UNITED STATES DEPARTMENT OF COMMERCE United States Patent and Trademark Office Address: COMMISSIONER FOR PATENTS P.O. Box 1450 Alexandria, Virginia 22313-1450 www.uspto.gov

APPLICATION NO.	FILING DATE	FIRST NAMED INVENTOR	ATTORNEY DOCKET NO.	CONFIRMATION NO.
10/812,846	03/30/2004	Toshihiro Suzuki	1324.70182	3124
24978 7590 02/02/2007 GREER, BURNS & CRAIN 300 S WACKER DR			EXAMINER	
			MAKIYA, DAVID J	
25TH FLOOR CHICAGO, IL			ART UNIT	PAPER NUMBER
CHICAGO, IL	. 00000		2885	
SHORTENED STATUTO	RY PERIOD OF RESPONSE	MAIL DATE	DELIVERY MODE	
3 MONTHS		02/02/2007	PAPER

Office Action Summary    Tolerand   Examiner   David J. Makiya   2875     The MAILING DATE of this communication appears on the cover sheet with the correspondence address   Period for Reply     A SHORTENED STATUTORY PERIOD FOR REPLY IS SET TO EXPIRE 3 MONTH(S) OR THIRTY (30) DAYS, WHICHEVER IS LONGER, FROM THE MAILING DATE OF THIS COMMUNICATION.   Extensions of time may be available under the provisions of 37 CFR 1.136(a). In no event, however, may a reply be timely filed after SIX (6) MONTHS from the mailing date of this communication.   If NO period for reply is specified above, the maximum statutory period will appl

Figure A: Linear light sources and reflection plate of Weber et al.

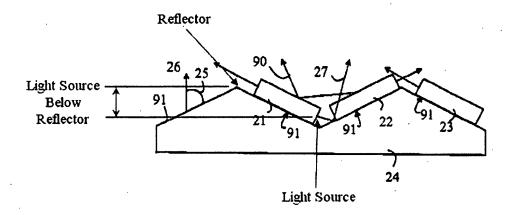
With respect to claims 3 and 5 and as best understood, Weber et al. teaches a surface lighting device comprising a surface light source in which linear light sources having lightemitting elements (21-23), which correspond to respective colors among combinations of plural colors including at least three primary colors of light (Column 1, Lines 19-21), arranged in series are arranged in a predetermined order; a reflection plate 91 which is laid so as to fill spaces among the light-emitting elements constituting the linear light sources; a substrate 24 which has linear projected portions 91 arranged at a fixed interval and on which the surface light source and the reflection plate are set (Figure 2), wherein each of the linear light sources is arranged on only one of a slope or a side of the linear projected portions arranged at the fixed interval on the substrate (Figure 2), such that the linear light sources are located above the substrate but below the reflection plate (Figure A), and an irradiation angle, at which an amount of light of the light emitting elements corresponding to at least one color among the plural colors is maximized according to the interval of the linear projected portions and an interval between the optical system 29 and the substrate is set according to an angle of the slopes or the sides of the linear projected portions (Column 1, Line 58-Column 2, Line 8). Because the references teach the structure of the claimed surface lighting device, the references would also teach that the interval L, the interval H, and the irradiation angle such that a relation of  $L \le 2 \times H \times tan$  (irradiation angle at which an amount of light of the linear light sources is maximized) is satisfied. Weber et

al. also teaches an optical system 29 being above the surface light source and reflection plate, but fails to teach the optical system being a diffusion plate. Johnson et al. teaches a lighting device comprising a surface light source 12, reflection plate 10, and a diffusion plate 20 which is located above the surface light source and the reflection plate (Figure 2). It would have been obvious to one of ordinary skill in the art at the time of the invention to modify the surface lighting device of Weber et al. with the teachings of Johnson et al. because a diffuser "convert light from lamp segments or discrete sources into a more uniform glow across the surface of LCD panel 18" (Johnson et al.; Column 6, Line 65-Column 7, Line 10).

In response to applicant's argument that Weber et al. does not teach light sources below the reflection plate, Figure A shows the light source below the reflection plate. In addition, this claim is objected to because it is unclear as to how the light source is below the reflection plate when the Applicant's figures show the light source being above the reflection plate.
